Technical Bulletin

Bulletin No: TCH-26-002 **Initial Release Date: 11/12/2025** **Revision Date: N/A** **Page: 1 of 1**

Subject: Bendix® AD-IP® Air Dryer Cartridge Load Plate Differences

Figure 1 - AD-IP Air Dryer Cartridge Load Plate Differences

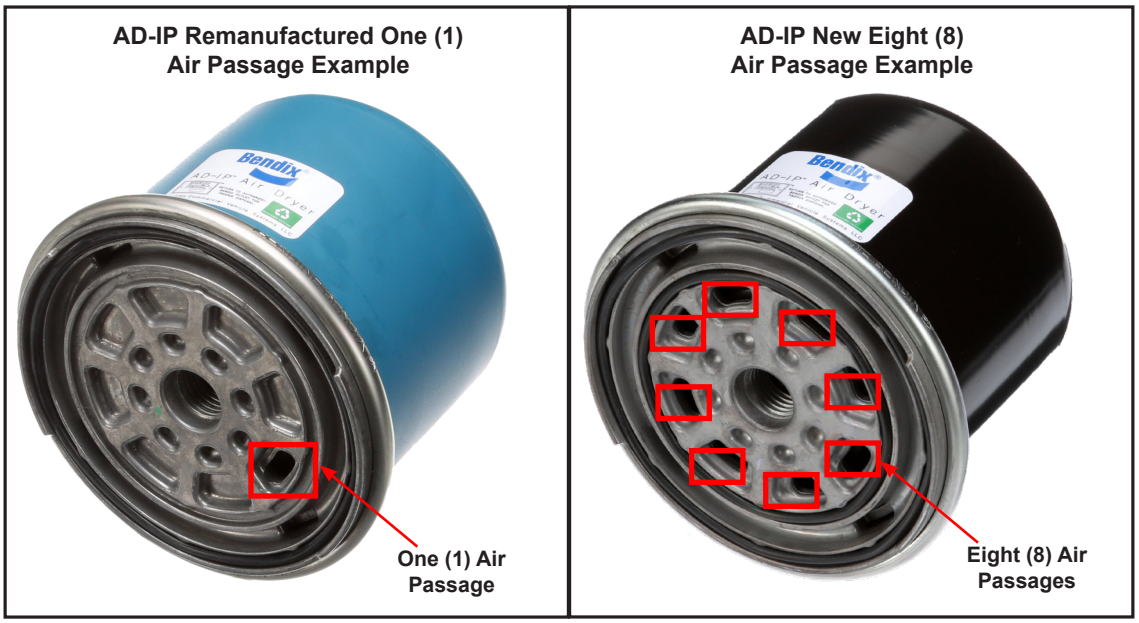
When replacing a Bendix® AD-IP® Air Dryer Cartridge, the load plate may appear different depending on the initial manufacturing date of the cartridge. The load plate may have one (1) or eight (8) air passages depending on when it was initially manufactured. There is no functional difference between the AD-IP cartridges as the number of air passages does not impact the cartridge performance.

The number of air passages on the load plate for the AD-IP cartridge can vary if it is ordered new or remanufactured. When removing an AD-IP cartridge from a vehicle and replacing the cartridge new or remanufactured from Bendix, the number of air passages on the load plate may vary as shown in *Figure 1* and does not warrant a return to Bendix.
